**TOWN OF NEWBURGH
PLANNING BOARD
TECHNICAL REVIEW COMMENTS**

PROJECT NAME: GARDNER RIDGE
PROJECT NO.: 2-29
PROJECT LOCATION: GARDNERTOWN ROAD NEAR GIDNEY AVENUE
SECTION 75, BLOCK 1, LOT 4.12
REVIEW DATE: 27 OCTOBER 2023
MEETING DATE: 2 NOVEMBER 2023
PROJECT REPRESENTATIVE: DARREN DOCE, P.E.

Re: ***Gardner Ridge***
Gardnertown Road
Section 75, Block 1, Lot 4.12

We are submitting twelve (12) copies of the revised Amended Site Plan sheets on behalf of Gardner Ridge Associates.

SANITARY SEWER PROFILE
SCALE: 1"=4' VERT.
1"=40' HOR.

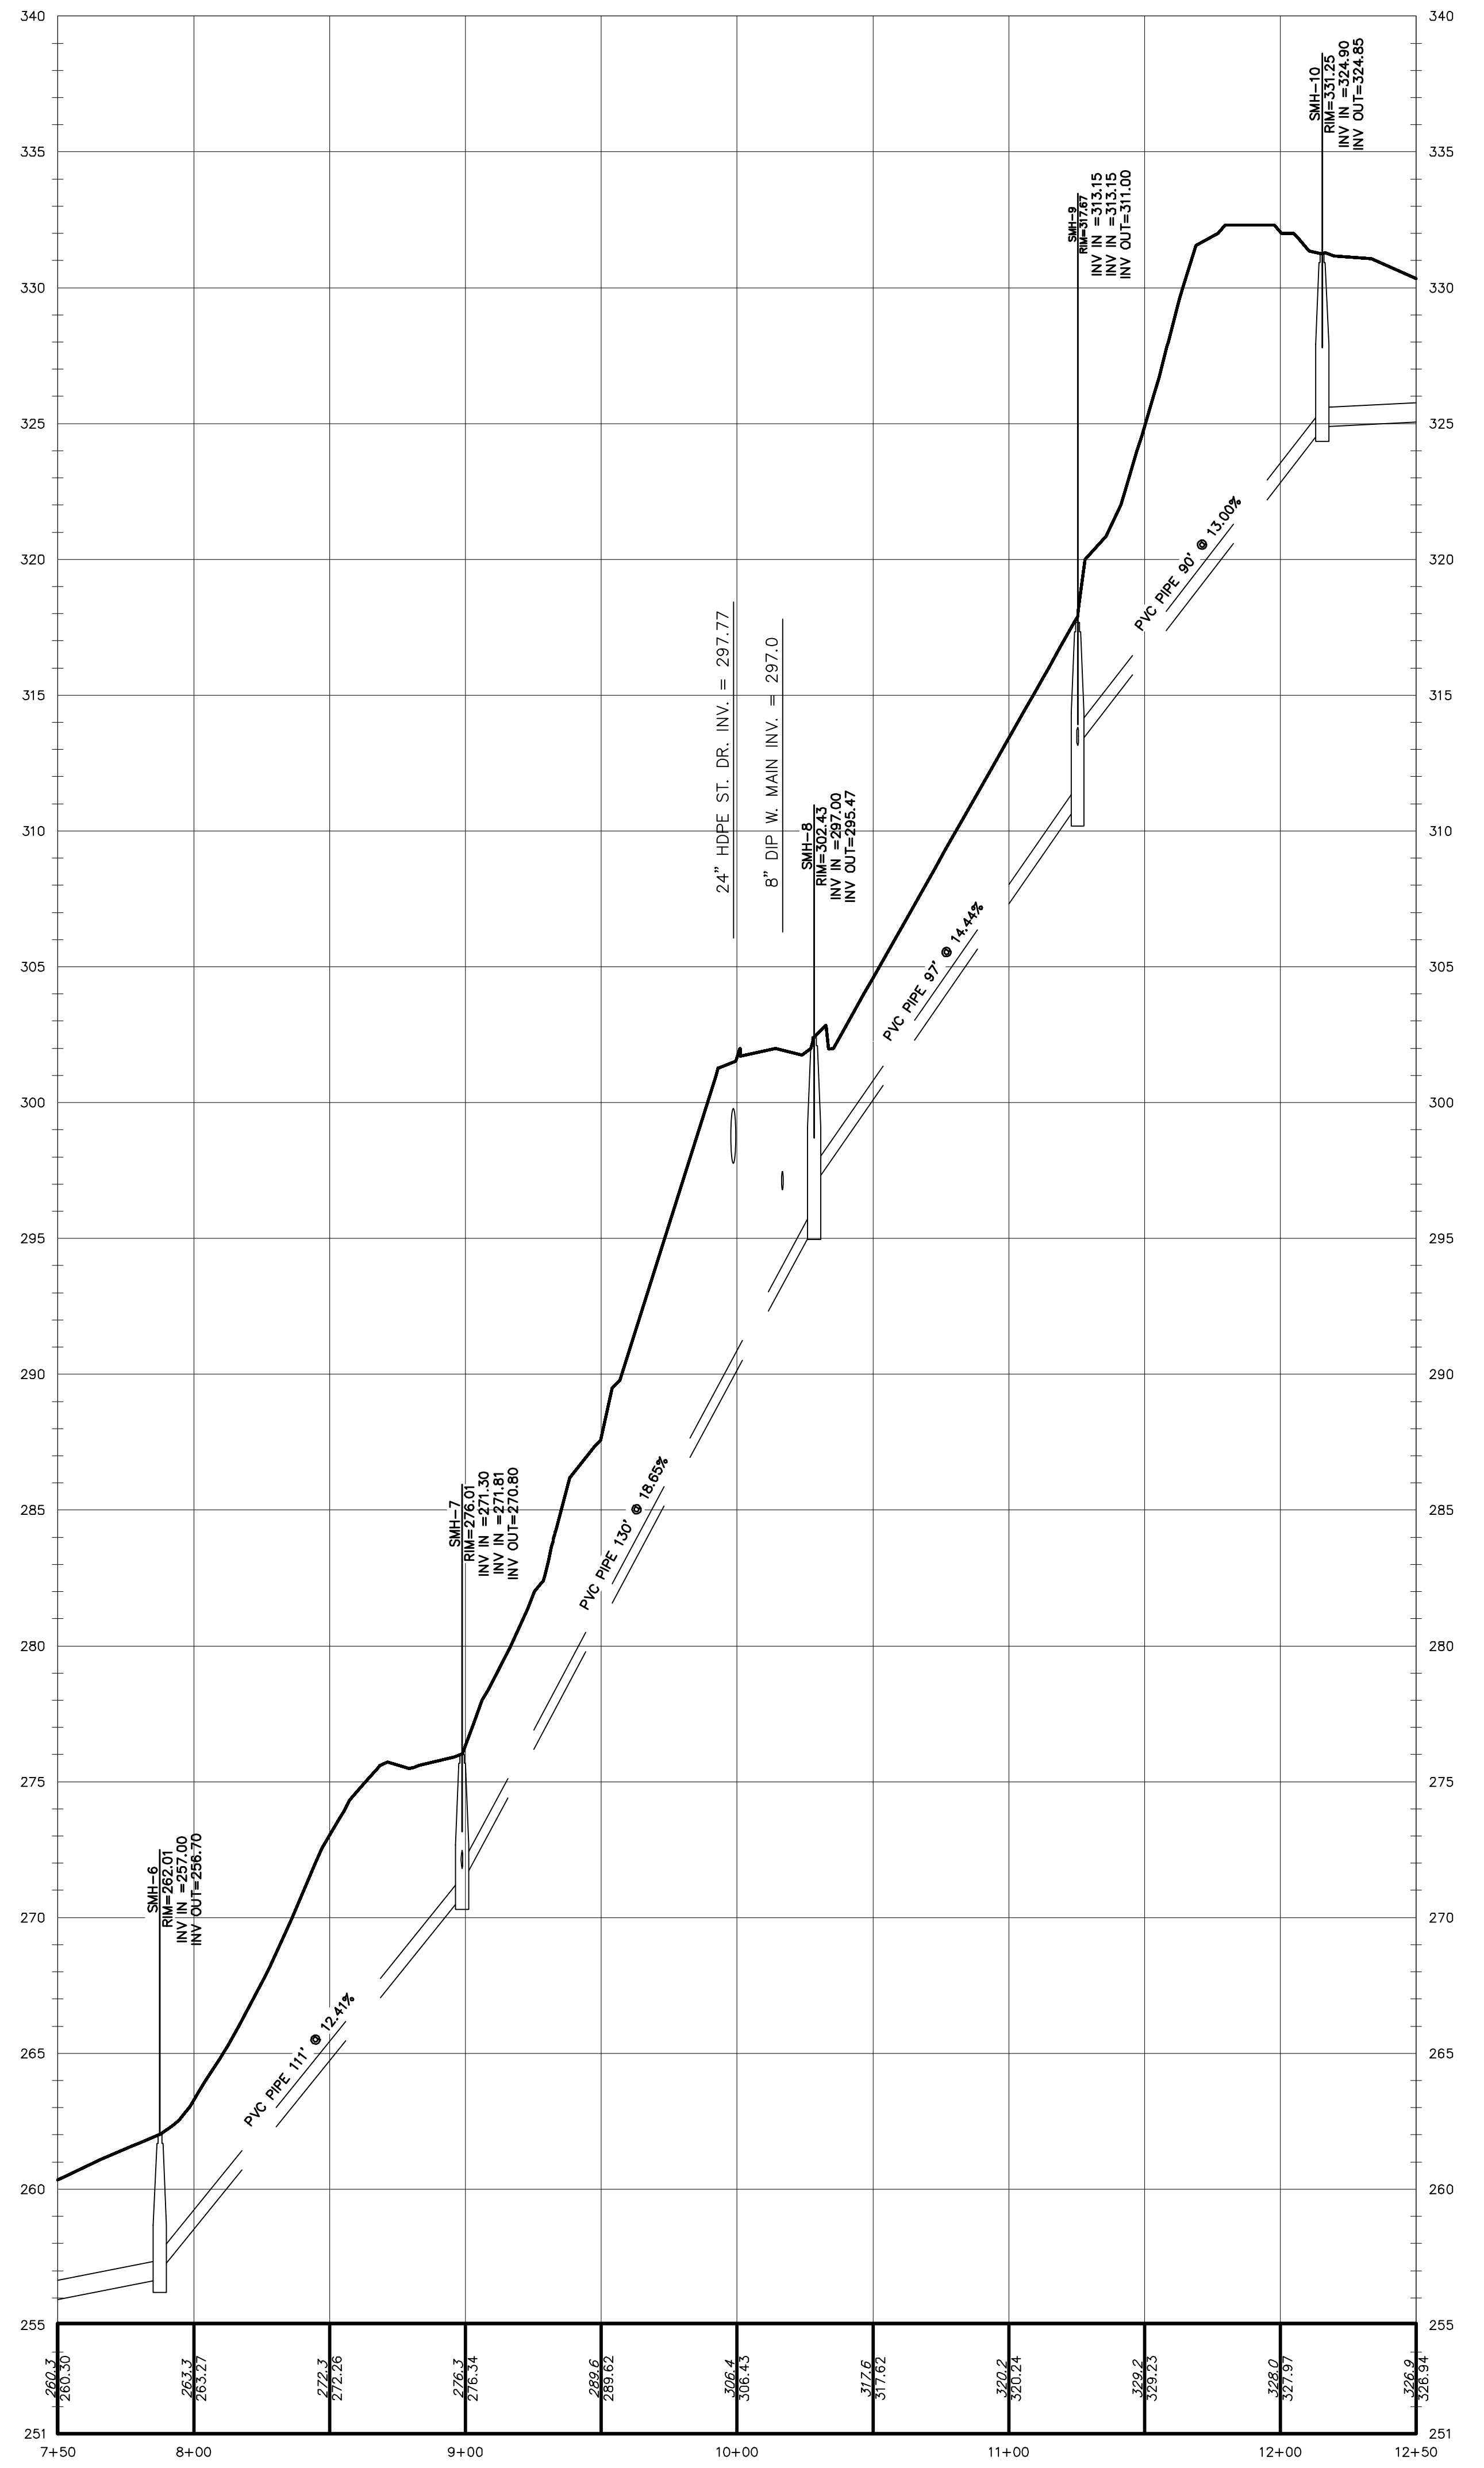
10. All Drainage and Water Main Crossings of the Sanitary Sewer Main have been added to the Profile Sheets.
11. The labels for the Sanitary sewer pipe between manholes 10 and 12 have been corrected.

VEGETATION STABILIZED SLOPE
NOT TO SCALE

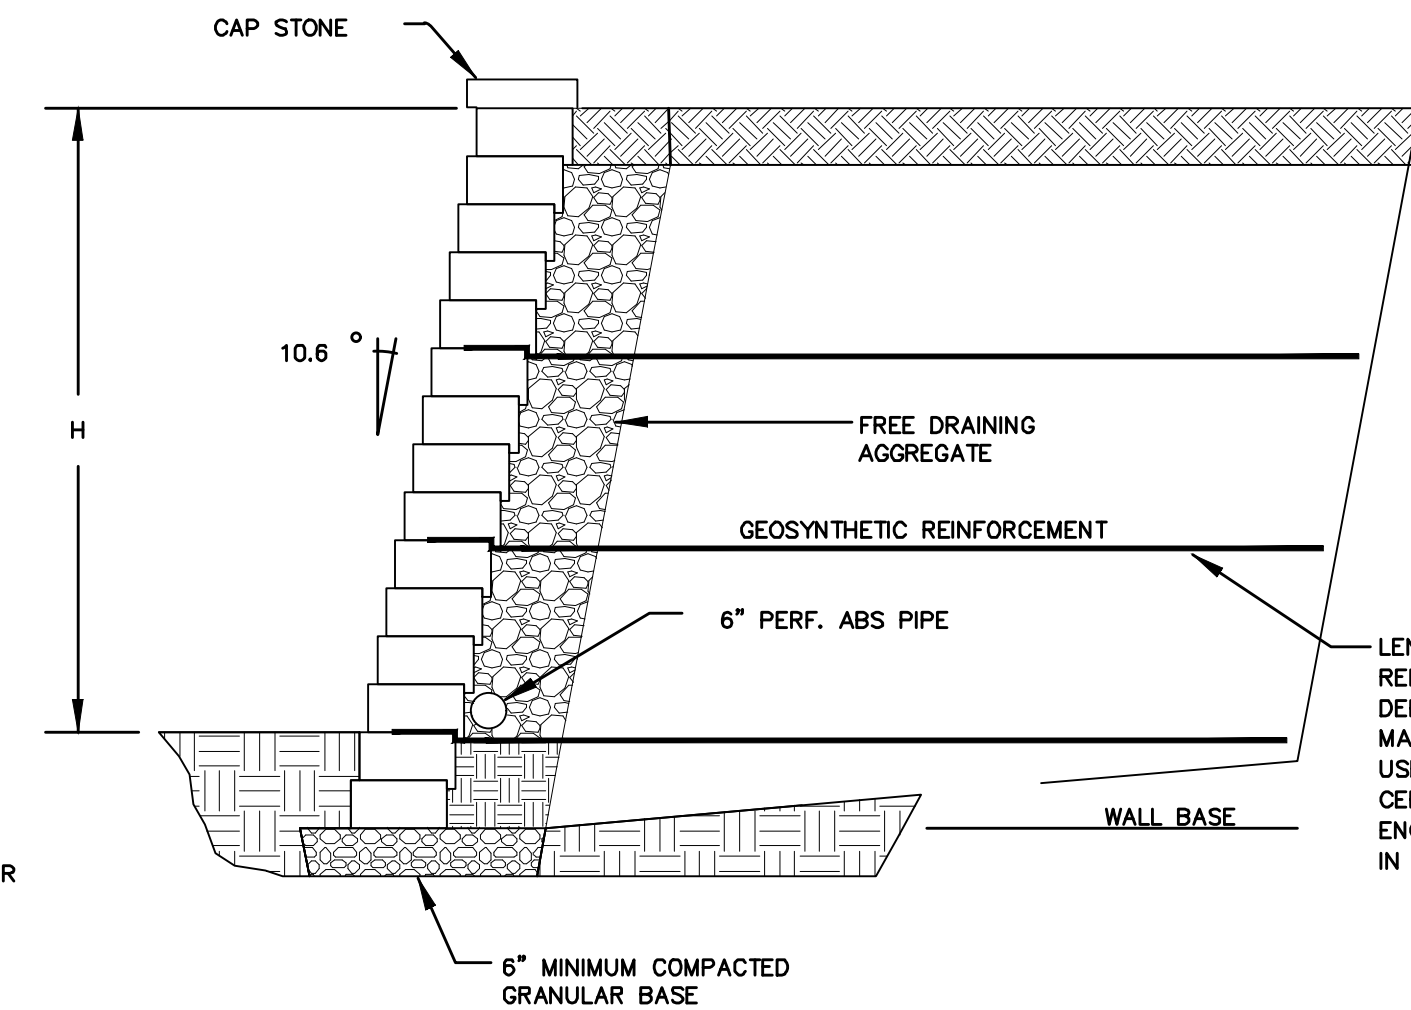
- Ken Mennerich – Recommended that instead of the riprap that a vegetative alternative be explored.

21. The sewer line to the rear of Buildings 1 and 2 has been fully labeled.
22. The rip-rap steepened slope has been redesigned as a vegetated steepened slope.

Response: The rip rap has been removed from the plans. We will finalize the treatment in this area with the Highway Superintendent to ensure that nothing significant will grow in that area to block sight distance.

EMERGENCY AND MAINTENANCE ACCESS GATE
NOT TO SCALE

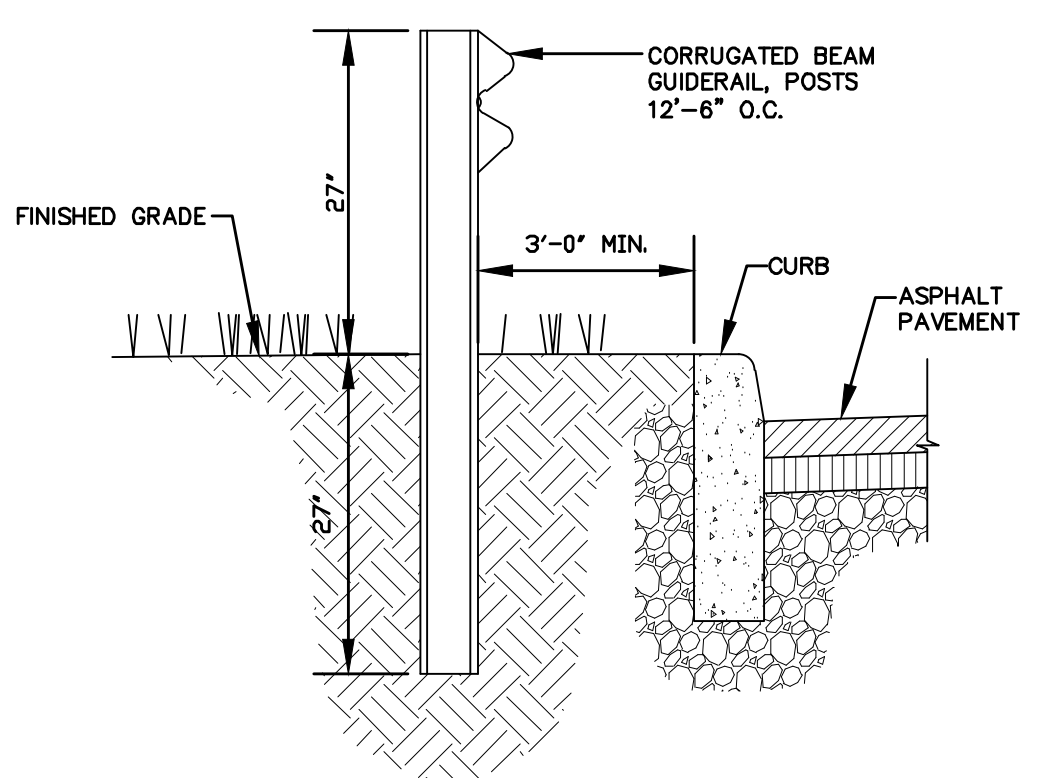
1. The revised site plan adds an emergency access point approximately 440 feet west (uphill) of the main entrance. The access is proposed to be grass pavers similar to that used across the street at Gardnertown Commons (Farrell). A detail of the emergency gate is provided, and it is noted in the letter to the planning board that there will be a gate installed at both ends of the emergency access, but they are not depicted on the plans. We suggest the gate near Gardnertown Road be located far enough off the road to allow an emergency vehicle to pull off the road before stopping and opening the gate.

Response: The gates and detail for such are now indicated on the site plans. The gate on the Gardnertown Road side is positioned to allow a fire truck to pull in off the road when opening the gate.

EROSION AND SEDIMENT CONTROL DETAILS
GARDNER RIDGE
GARDNERTOWN ROAD
TOWN OF NEWBURGH, ORANGE COUNTY, NY

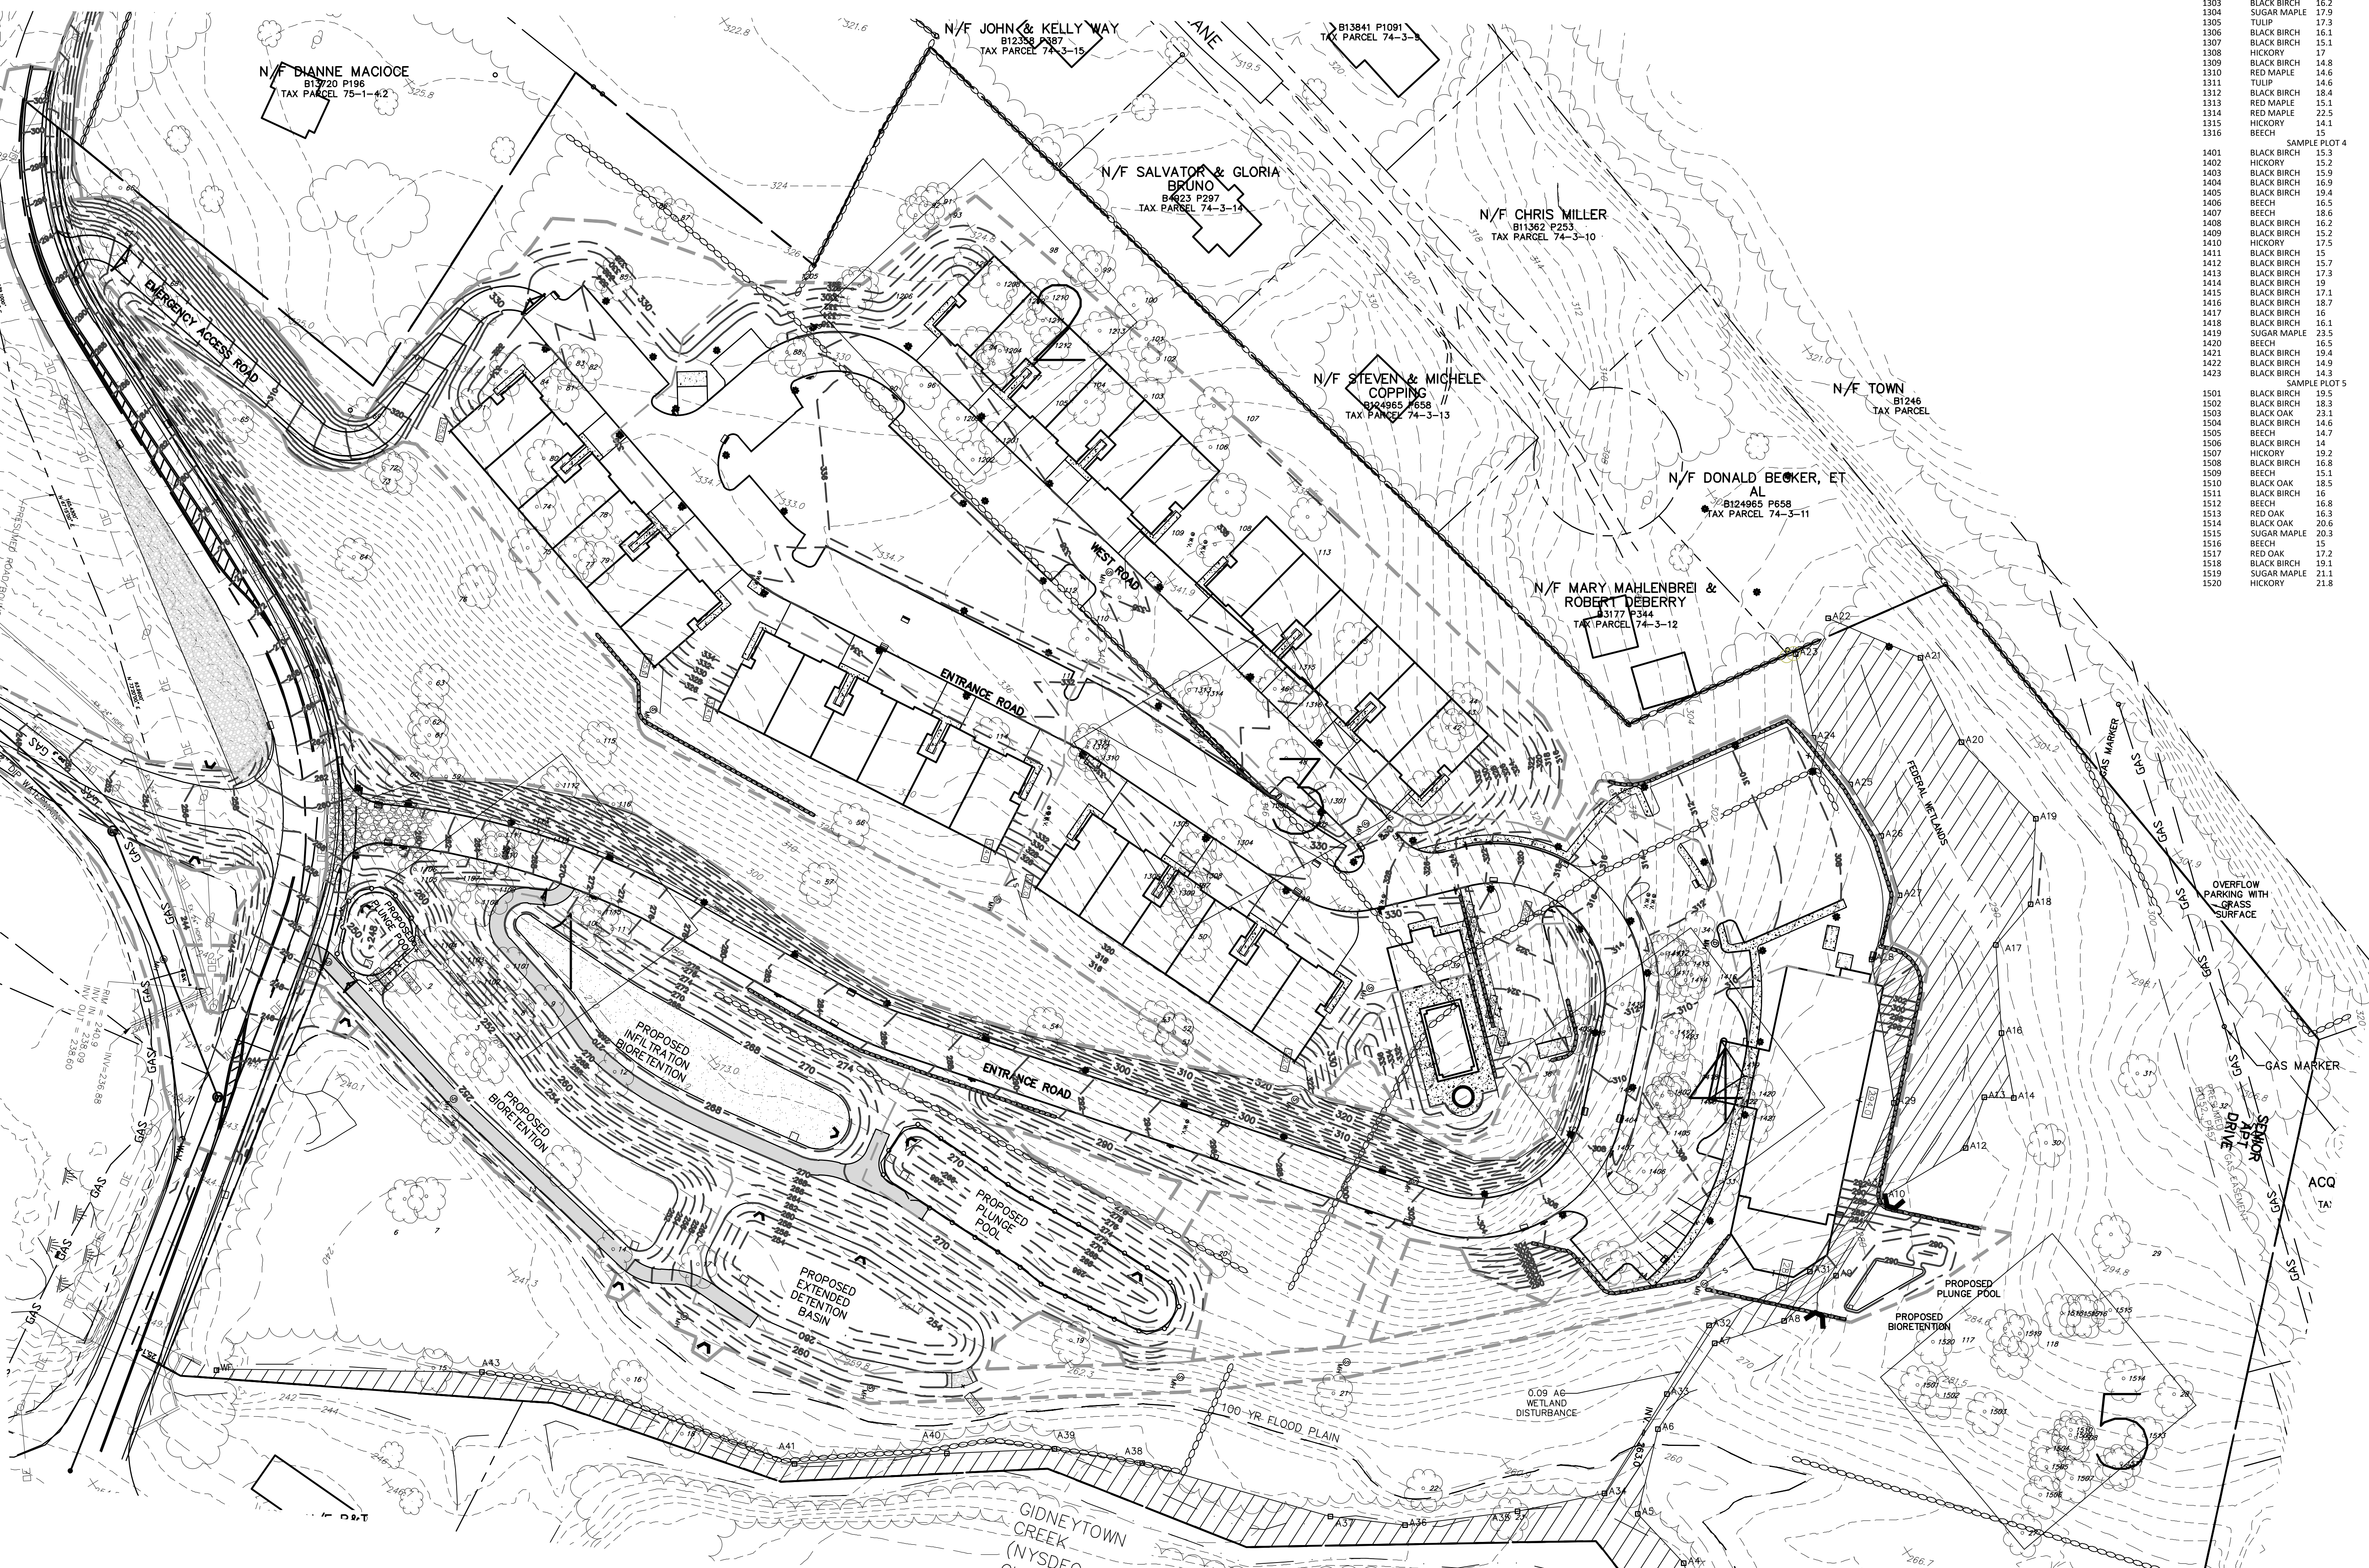
1. A Tree Survey has been conducted in accordance with the Town's Tree Preservation Code. The results of the tree survey and the required calculations are shown on a newly added Sheet 16 of the Site Plan Set.
2. Highway Supervisor comments have been addressed in separate correspondence from Collier's Engineering.
3. The Project has been resubmitted for County Planning review.
4. The Project has been re-circulated under SEQRA.
5. Health Department Approval will be renewed following the Board's SEQRA determination.
6. All work has been relocated outside of the 100 Year flood Boundary.
7. Access gates have been shown on the site plan for both the emergency and maintenance access drives. The location of the gates along Gardnertown Road are situated to allow emergency or maintenance vehicles to pull in and not block Gardnertown Road.
